JEFFERSON COUNTY
LAW ENFORCEMENT CENTER
JEFFERSON, WISCONSIN

FIRST FLOOR PLAN — 6-11-90
1/8"=1'-0" — E-6
POWER, COMM. & DATA

AS BUILT
DEC 6, 1994

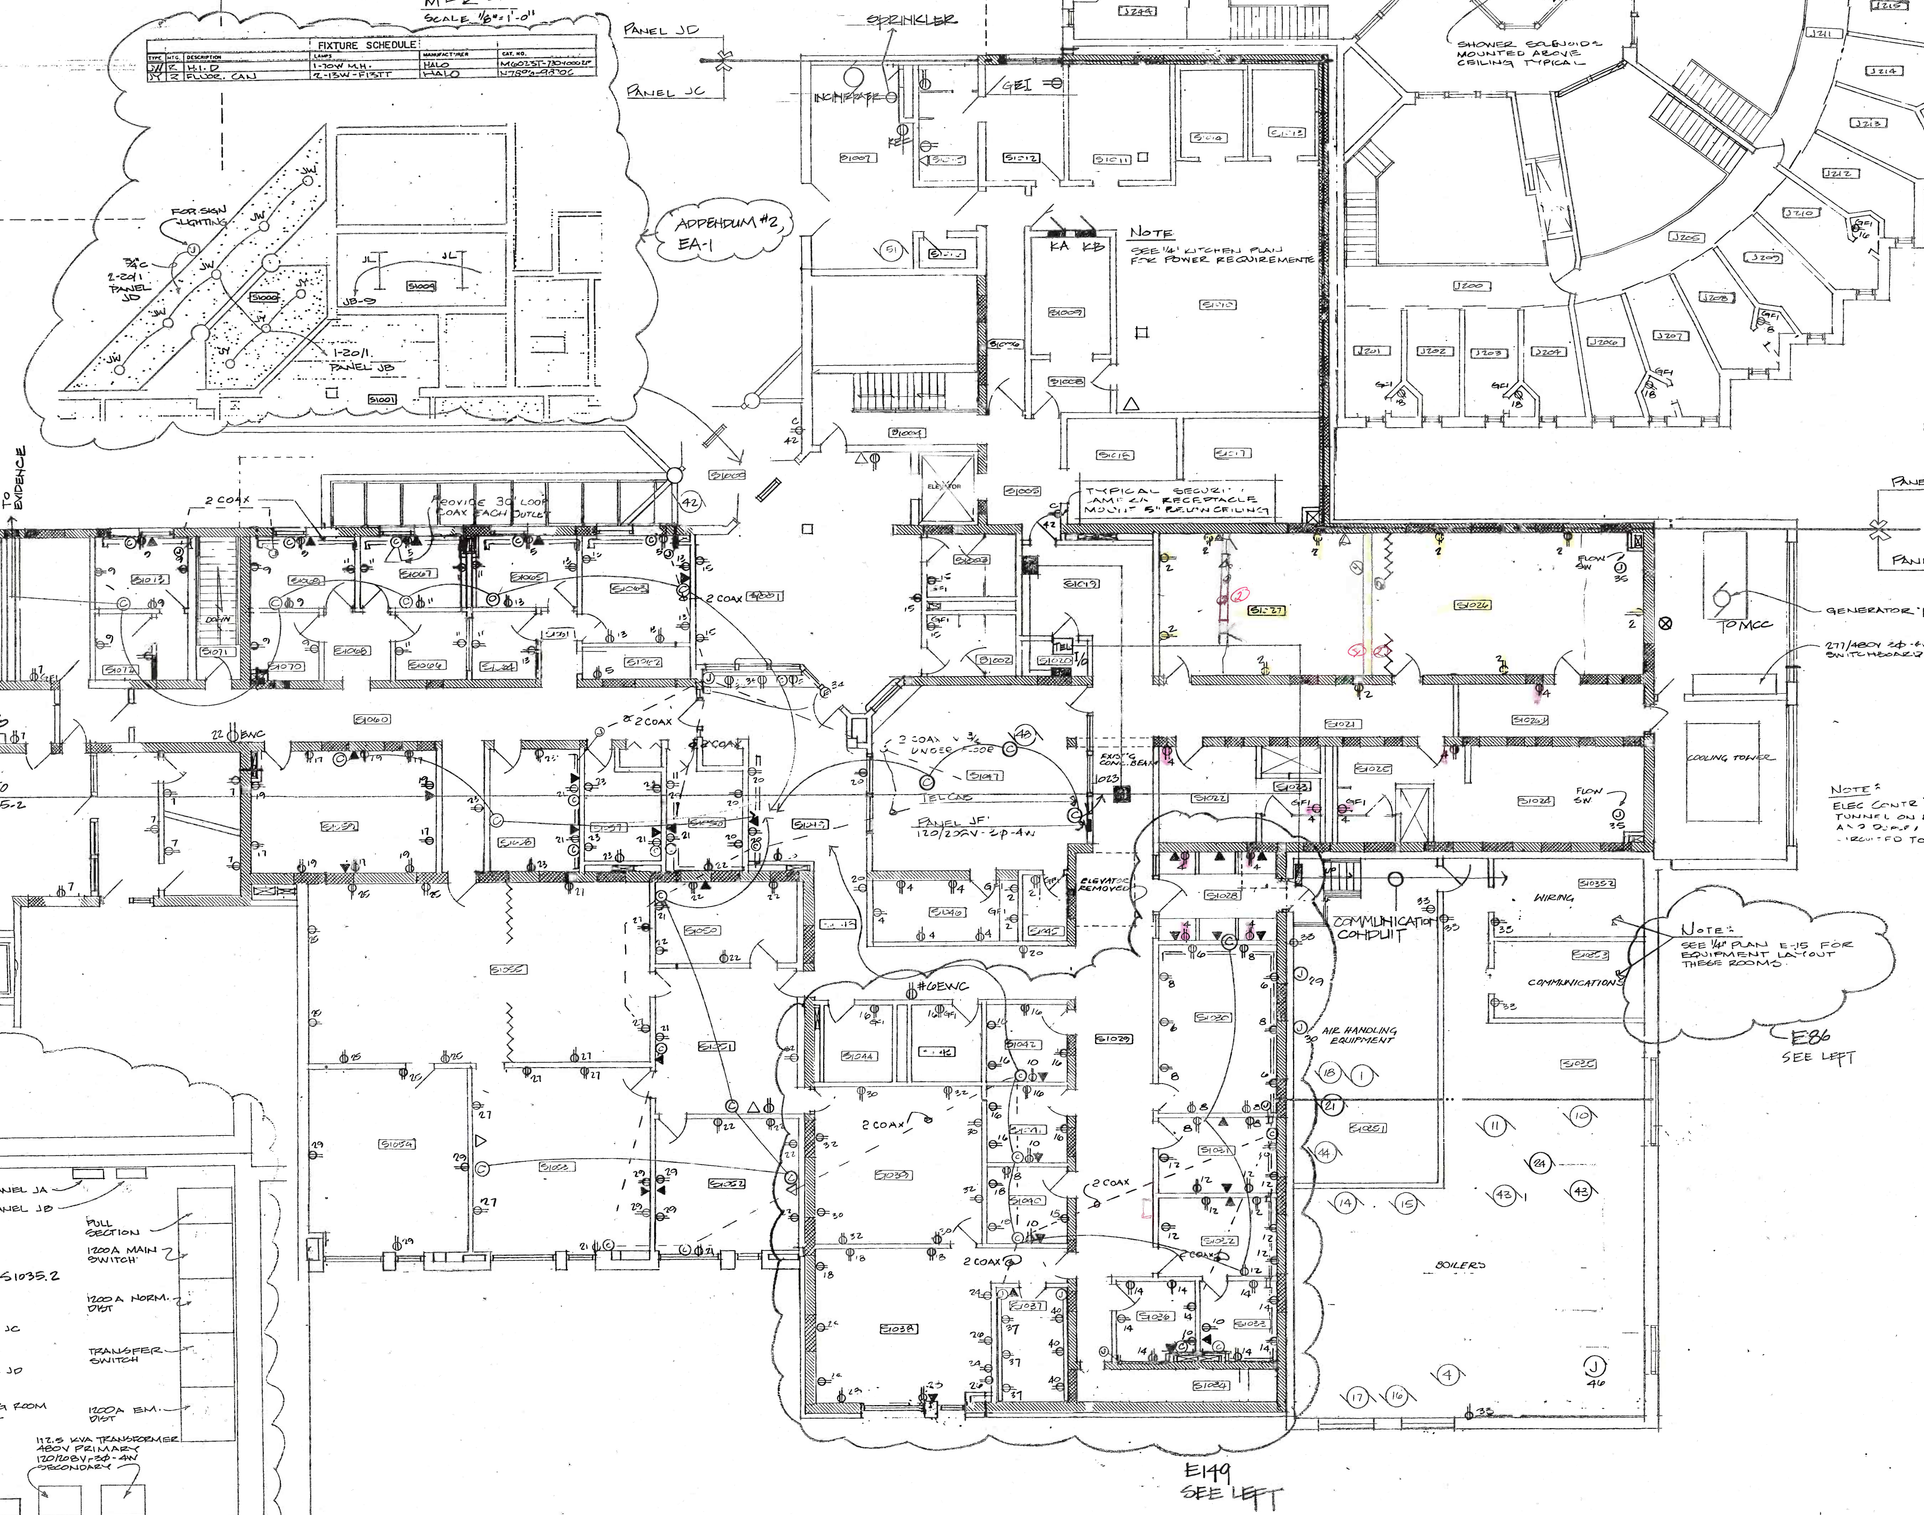
1. Add 'GFI' receptacle adjacent to sink in Room S1015.
2. S1047 - Add 1 receptacle on East wall 12' 0" off South wall. Add 1 receptacle on North wall above counter. Add 1 receptacle on West wall 9' 0" off North wall.
3. Louver in generator room to be motorized and interlocked with generator.
4. Add receptacle and telephone jack on East wall of Room S1001 adjacent to door for public telephone.
5. Add receptacle for EWC corridor S1048.
6. Add connections for incinerator in Room J093.
